DETAILED ACTION

In re Application of		Sai C. Yun, et al.	
Application Number		Filed	
09/814,828.		March 23, 2001	
For: TAPE CARRIER PACKAGE WITH DUMMY BENDING PART AND LIQUID CRYSTAL DISPLAY EMPLOYING THE SAME			
Art Unit	2812	Examiner	A. Roman

AMENDMENT

Figure 6

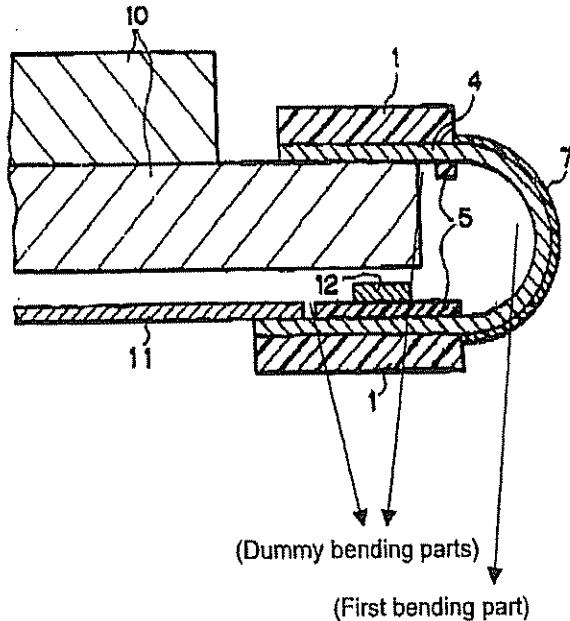
5. Claims 5 and 9 are rejected under 35 U.S.C. 102(b) as being anticipated by Tagusa et al. U.S. Patent 5,668,700 A.

Tagusa et al. discloses A tape carrier package, comprising; a pad part for connection to a liquid crystal panel; a base film mounted with an integrated circuit chip 1 for applying a signal to the liquid crystal panel; and a dummy bending part, for distributing a stress applied to the liquid crystal panel according to a thermal expansion of the pad part by removing a portion of the base film between the pad part and the

integrated circuit chip 1. The tape carrier package further comprises a second pad part for connection to a printed circuit board (see figure 6).

For example, the structure of claim 5 of the present invention is different from the Tagusa structure in that in Tagusa, the substrate 2 is partially removed only where the wiring board 42 is folded (Tagusa, elements 2b and 2c in Figure 6 and column 14, lines 24-55). Furthermore, in Tagusa, no part of the substrate 2 is removed between the pad part and the integrated circuit 1 as required by the claim.

FIG. 12

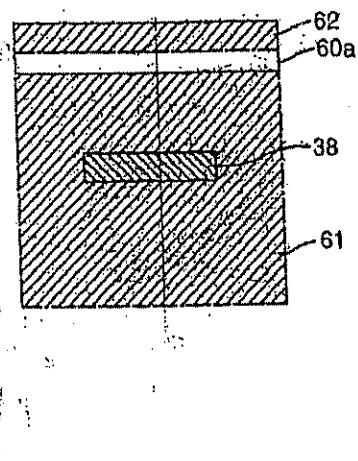
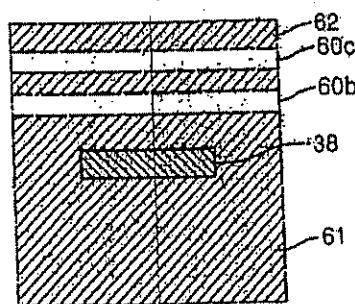
The attached sheet of drawings includes changes to FIG. 12. This sheet, which includes FIGs. 12-13, replaces the original sheet including FIG. 12-13. In FIG. 12, the line C-C has been removed.

Applicant also submits a new formal drawing for Figure 12 in an Appendix to this Paper.

FIG. 12

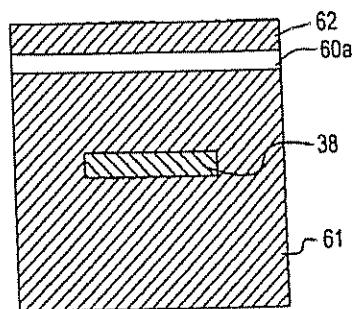
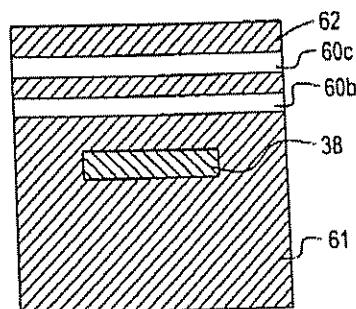
SPECIFICATION	MESSAGE Sheets/Figs - Fig 12 i/13 lines in the drawing.																	
	Please Resolve																	
CLAIMS	RESPONSE (SEE ATTACHMENT) CORRECTED DWS																	
	Thank you initials J.S.
